Sheet: /
File: power-service.kicad_sch
Title: NOVA power—only / buffer / RDM service hardware — PROTOTYPE
Size: A1 | Date: | **Rev: C—POWER-REVIEW-FIX**
KiCad E.D.A. 10.0.7 | Id: 1/1

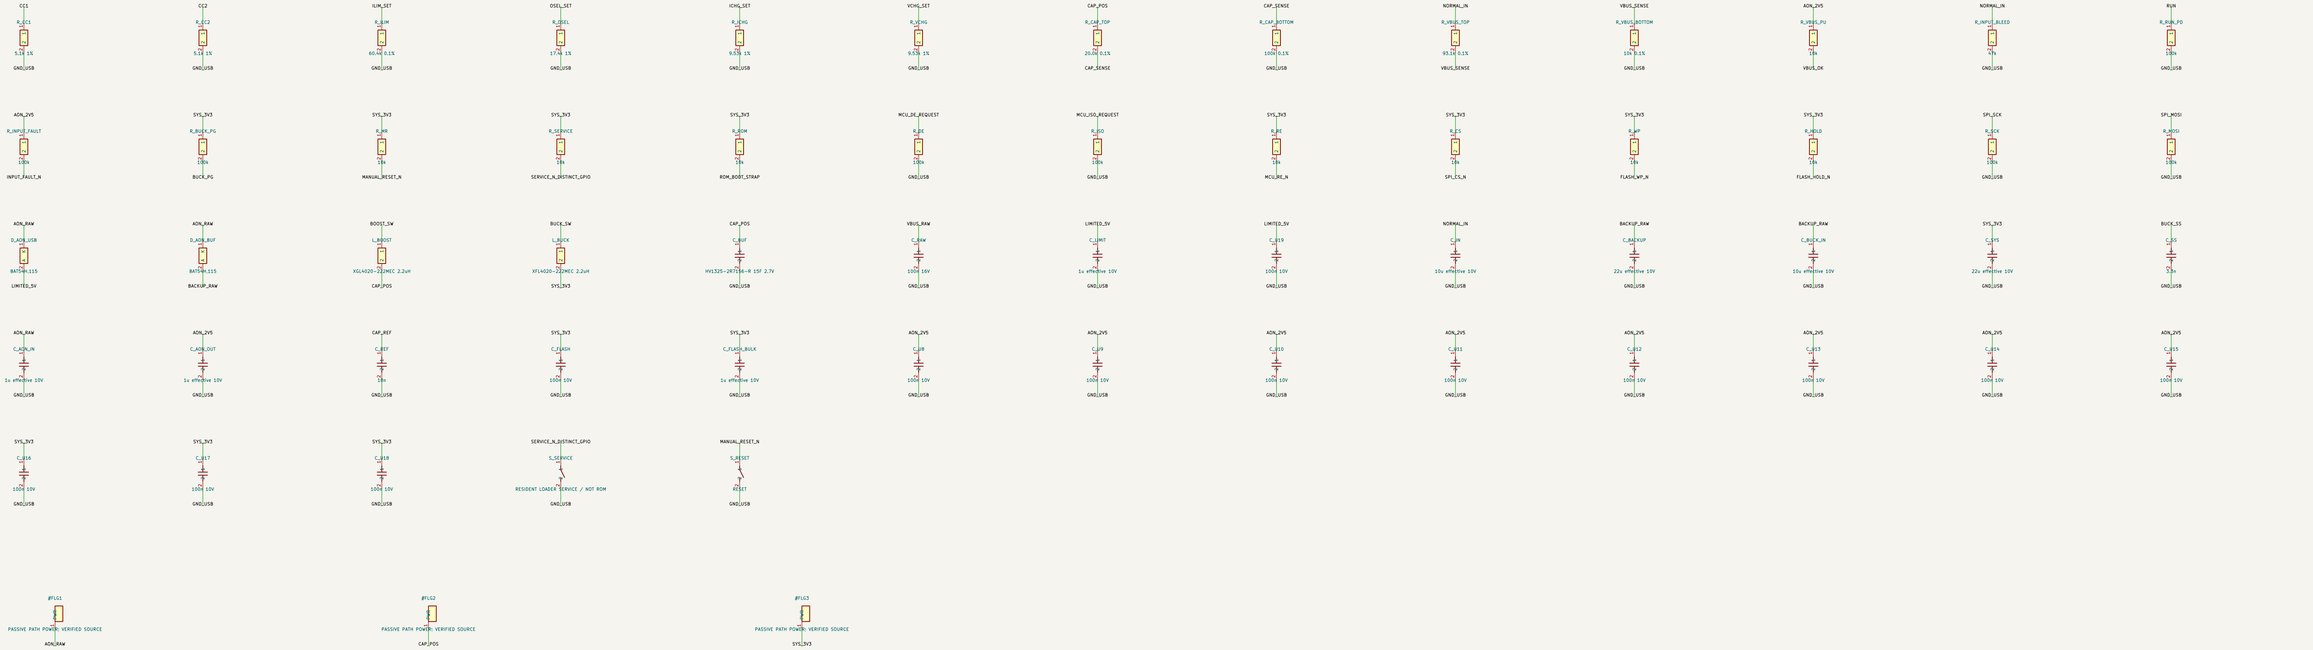
CURRENT POWER-ONLY DESIGN: USB data pins NC. <=500mA PSD design basis: COLD START NOT ACCEPTED (ISS max unknown).

Cap latch: PRE_N=(VBUS_OK & ADN_OK); CLR_N=ADN_OK & (CAP_OK | VBUS_OK); RUN=Q & ADN_OK.

MODE=AGN_RAW independent of RUN. U19 low-loss reverse barrier: U10 senses actual NORMAL_IN (no slow input RC).

SERVICE is distinct from ROM strap; MCU pin allocation lives in mcu-radio/. Power boundary numbers are not package pins.

MCU/RF and existing ISOW1412 sheet are explicit boundaries: no resident ROM loader, security/update code or PCB routing claimed.

15F at2.6V /25mA charge: runtime must subtract 100mV charge hysteresis. Stable source/PG still cannot promise future commit energy.
